MIL-A-23595D(AS)
AMENDMENT 1
25 February 2000

AMPLIFIER AUDIO FREQUENCY

This amendment forms a part of MIL-A-23595D(AS), dated 14 April 1995, and is approved for use by the Naval Air Systems Command, Department of Navy, and is available for use by all Departments and Agencies of the Department of Defense.

FIGURE 4. Typical amplifier pin stress to breakage test configuration.

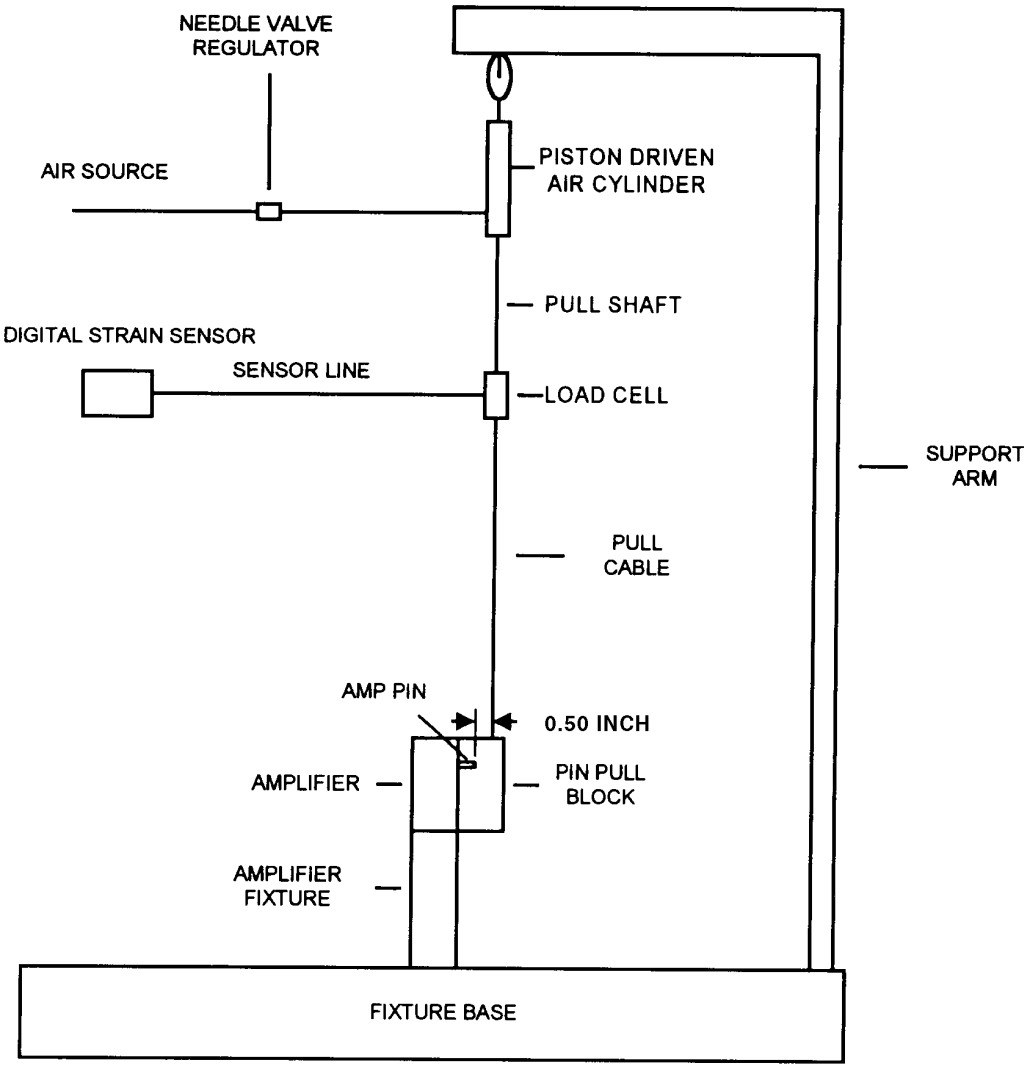
FIGURE 4:	Replace: "FIGURE 4" with new "FIGURE 4"

4.7.23:	Add after 1st sentence: "The line of force shall extend 0.50 inch minimum beyond the end of the pins."
